Access Compliance Report

Public Rights-of-Way

Intersection ID: 12182	Main Street: BRYANT_ST	Cross Street: S_SUMMIT_AV	Location: NW
ADA ID: 742715A495AD	Ramp Type: BlendTrans1	Initial Pass/Fail: Fail	Overall Compliance: No
		Severity Score: 1.25

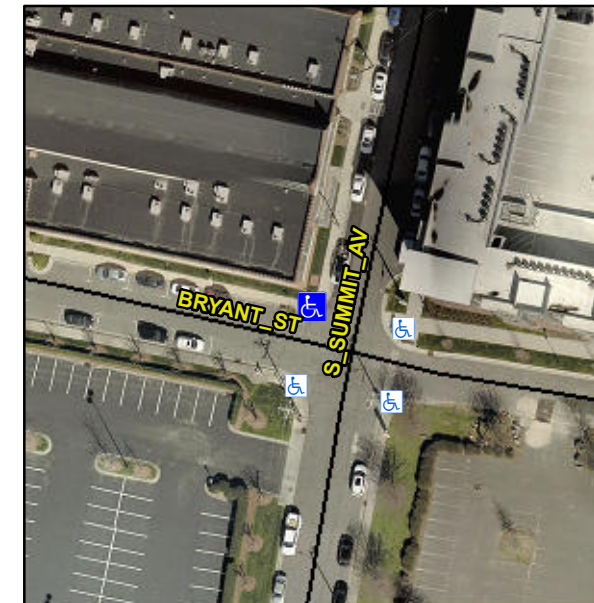
Compliance	Description	Data	Compliance	Description	Data
N/A	Ramp Length (in)	60.0	Yes	BlendTrans Slope (%)	2.4
Yes	Ramp Width (in)	48.0	No	BlendTrans XSlope (%)	2.3
N/A	Flare Type LT	N/A	N/A	Flare Type RT	N/A
N/A	Flare Slope LT (%)	N/A	N/A	Flare Slope RT (%)	N/A
N/A	Flare Traversable LT?	N/A	N/A	Flare Traversable RT?	N/A
N/A	Landing Length (in)	N/A	N/A	DWS Provided?	N/A
N/A	Landing Width (in)	N/A	N/A	DWS Contrast?	N/A
N/A	Landing Slope (%)	N/A	N/A	DWS Length (in)	N/A
N/A	Landing X Slope (%)	N/A	N/A	DWS Full Width?	N/A
N/A	Landing Curb? (Y/N)	N/A	N/A	DWS Offset (in)	N/A
N/A	Shared Landing?	N/A			
N/A	Gutter Ponding?	N/A	N/A	Gutter Slope (%)	N/A
N/A	Gutter Lip Ht (in)	N/A	N/A	Gutter X Slope (%)	N/A
N/A	Painted X Walk1?	No	N/A	Painted X Walk2?	No
	X Walk 1 Direction	To S		X Walk 2 Direction	To E
	X Walk 1 Width (in)	N/A		X Walk 2 Width (in)	N/A
	X Walk 1 Slope (%)	2.9		X Walk 2 Slope (%)	2.5
	X Walk 1 X Slope (%)	0.3		X Walk 2 X Slope (%)	1.2

Remove & Replace Curb Ramp With Two New Directional Ramps or Equivalent.
